CHAPTER 4

CASK RESPONSE TO FIRE ACCIDENTS

Figure 4-1. Cask lying on ground concentric with fuel pool

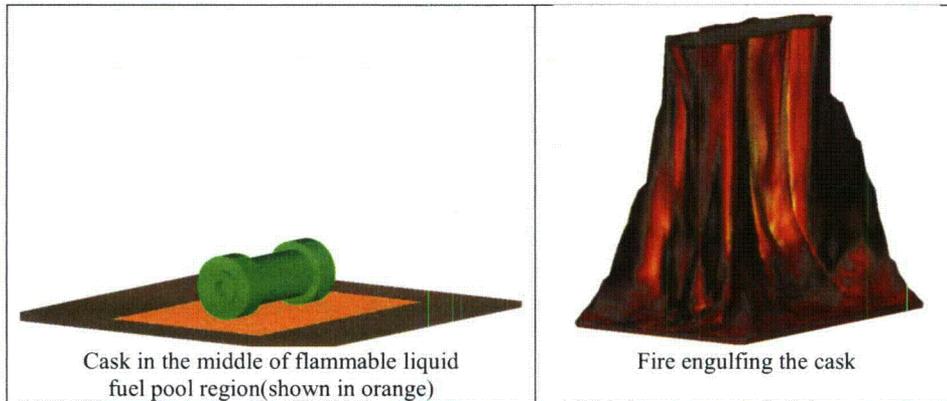
Comment [XXX3]: As discussed during the meeting at SNL, making the assumption that the pool fire extends 3 meters on each side of the cask leads to a pool fire that is much shorter in duration than one that extends 3-m from the cask (I believe we calculated it to be 7.5 hours for the 1-m extension and 3 hours for the 3-m extension) (not to mention that the bigger fire is also cooler at its center due to oxygen deprivation). I am fine with using a 3-hour duration, but this should not be the justification for it. Rather, as we discussed at SNL, historical data showing that a 3-hour fire is a good estimate of the near worst-case fire that could be encountered should be used to justify this duration. We discussed that Chris Bajwa could provide the historical data to make the justification.

Figure 4-4. Regulatory pool fire configuration.

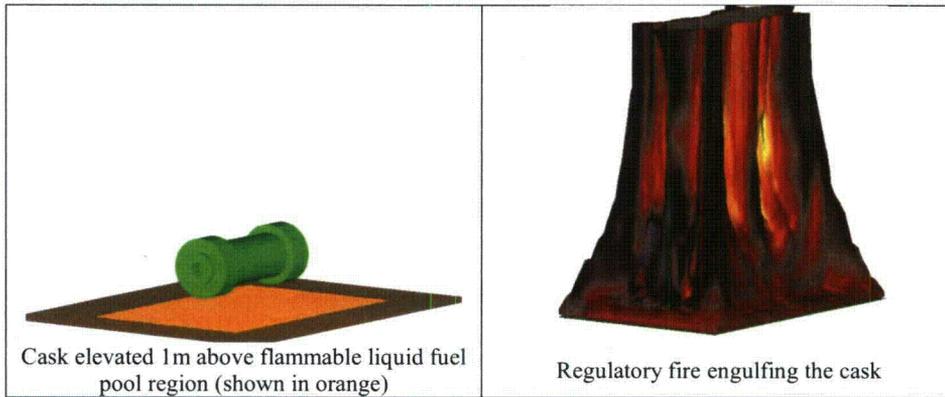
Comment [XXX4]: Why are these analyses performed (i.e. what is their purpose)? Please provide some additional explanation as to why these additional analysis were done.

Figure 4-6. Finite element models of the two rail casks analyzed

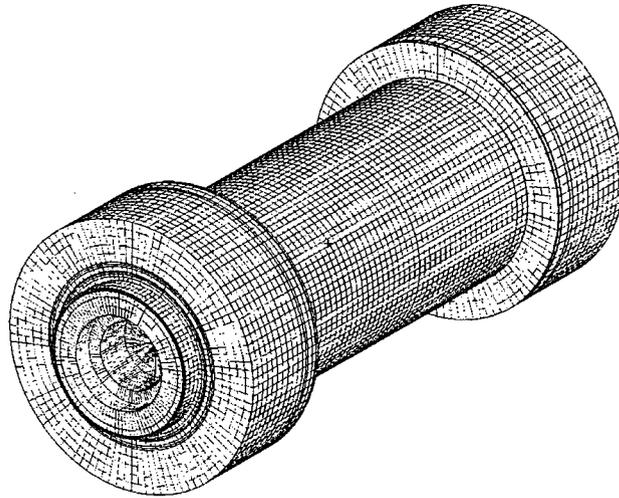
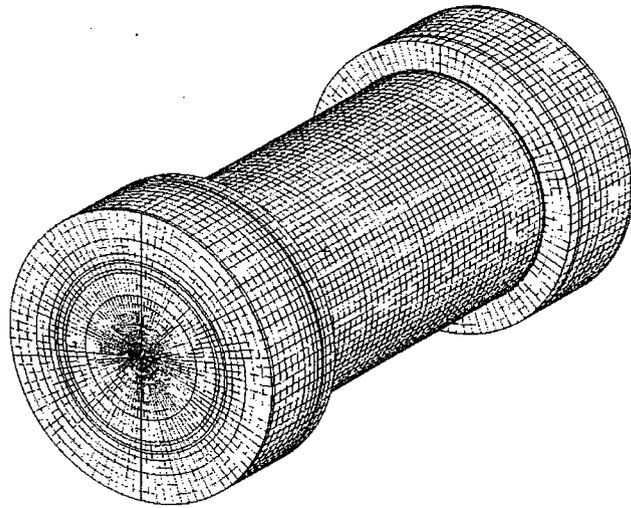
Comment [MF5]: – the polymeric neutron shield is assumed to melt completely and be replaced by air for all the three casks. The loss of this shield is not mentioned at all later in the Partial Summaries of page 87, page 96, page 101, and in the Chapter Conclusions, page 102. For completeness, the loss of this shield should be mentioned in the Summary sections and in the Chapter Conclusions.

Figure 4-8. Temperature of key cask regions, Rail-Steel cask – Regulatory uniform heating

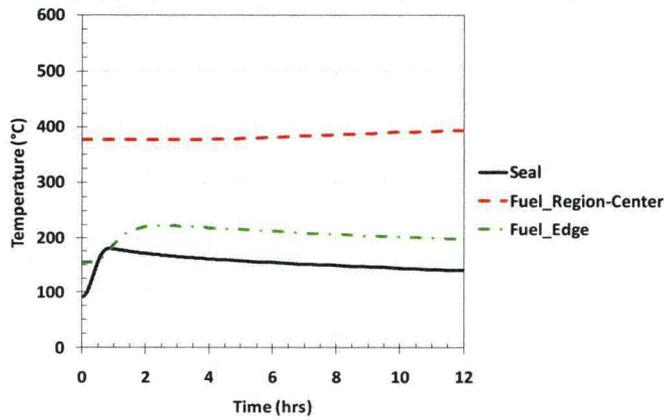
Comment [XXX7]: The use of the term "fuel" in the figure key is somewhat confusing. This refers to the spent nuclear fuel, but it could be interpreted to refer to the fire fuel. Please rephrase as either "spent fuel" or "content fuel". This comment applies to several figures.

Figure 4-11. Comparison of regulatory fire analysis - Rail-Steel cask: Uniform heating vs. CAFE fire

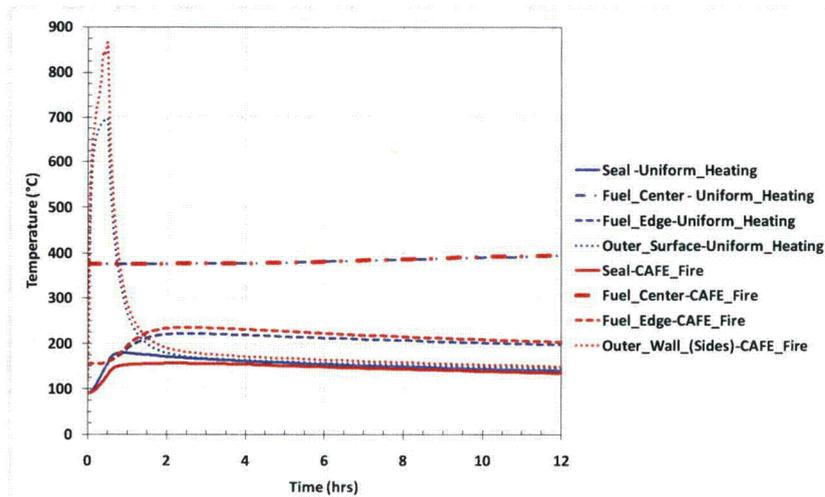
Comment [MF8]: Comparison with Fig. IV-11, page 397 of Appendix IV, there is a discrepancy for the outer wall (sides) temperature CAFE fire. Value under 900°C in Fig. 4-11 and over 900°C in Fig. IV-11.

Figure 4-15. Temperature of key cask regions, Rail-Steel cask – Cask on ground, concentric fire

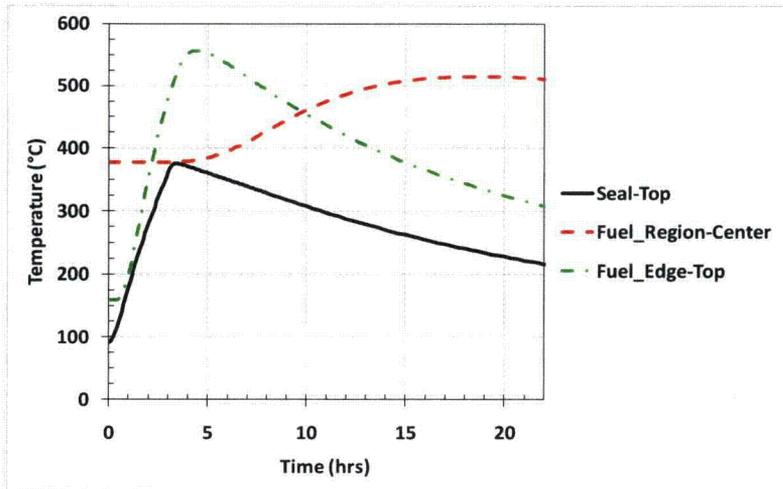
Comment [XXX9]: It is surprising that the *Seal-Top* and *Fuel_Edge-Top* temperatures peak so quickly after the fire, especially when compared to the *Fuel_Region-Center*. However, this finding is relatively consistent throughout the various analyses.

Figure 4-26. Comparison of regulatory fire analysis – Rail-Lead cask: Uniform heating vs. CAFE fire

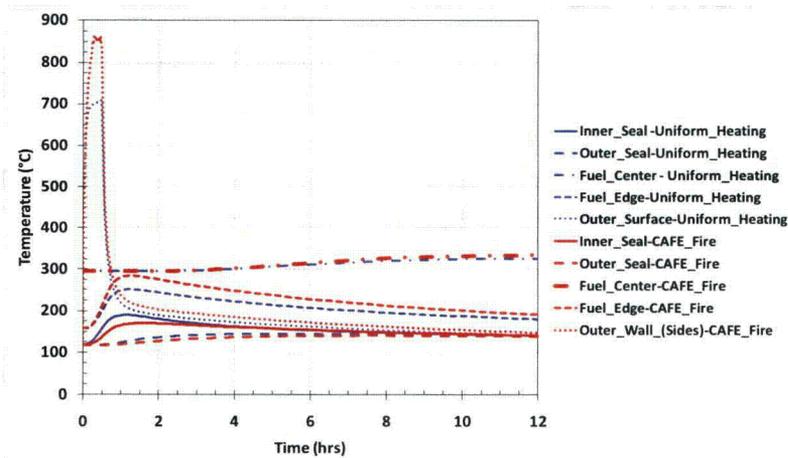
Comment [MF10]: Fig 4-26, and Fig. IV-21 page 418 (Appendix IV) – temperature of outer wall CAFE fire is below 900°C (50C) in Fig. 4-26 but it is well over 900°C in Fig. IV-21. This is the same comment of Page 78 – Fig. 4-11.

Figure 4-33. Rail-Lead cask lead gamma shield region - maximum lead melt at the middle of the cask – Scenario: Cask on ground, 3-hour concentric pool fire

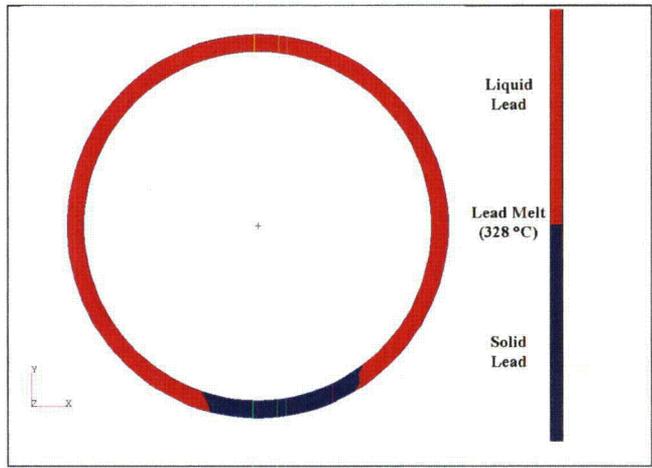
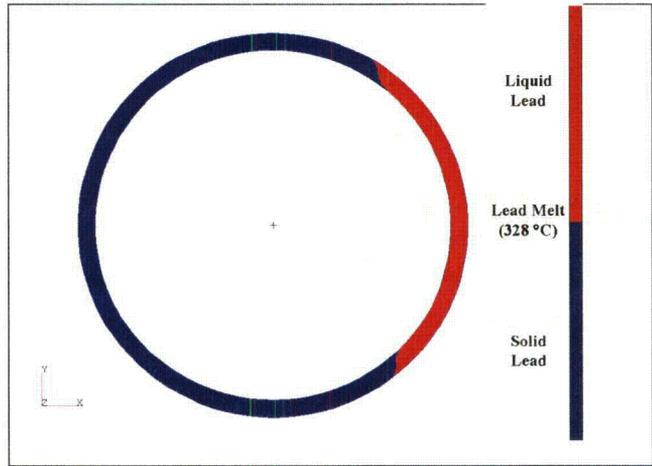
Comment [MF11]: Melting of the lead shield, appears to be very small, only 8.1% and 2%. These amounts cannot be checked - further details of these calculations should be provided so that they can be checked independently.
